# Z-101-2016 GIS

Planning Staff Analysis

## **Z-101**

**REVISED SUBJECT TO SITE PLAN RECEIVED JAN. 25, 2017**Contact: Philip Westbrook (770) 528-2014

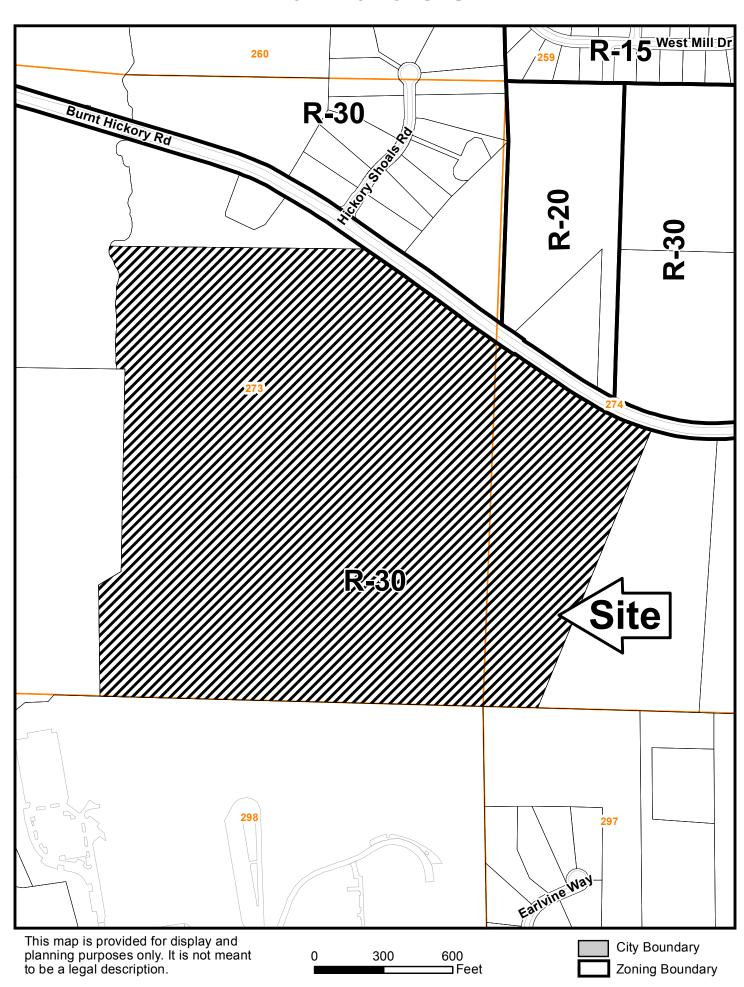
Land Use Plan Recommendat Proposed Number of Units:		ensity: 1.33	Units/Acre
Land Use Fian Recommendat		` 1	
Land Use Plan Decommendat	ion: Very Low Density Resid	dential (0-2 units per acr	re)
ZONING COMMENTS:	Staff Member Responsible:	Jason A. Campbell	
***********	1		* * * * * * * * * *
PRESENT ZONING: R-30		PETITION FOR:	R-20 / OSC
DDECENT ZONING. D 20

Applicant is requesting the R-20/OSC zoning district for the purpose of developing a 100-lot open space residential subdivision. The proposed houses will range in size from 2,800-3,800 square feet and will be traditional architecture. The prices will range from \$450,000 to \$650,000.

The overall tract consists of 87.639 acres, of which 39 acres (44.5%) has been set aside as open space. The proposed plan indicates an amenity area that includes a clubhouse, pool and tennis courts.
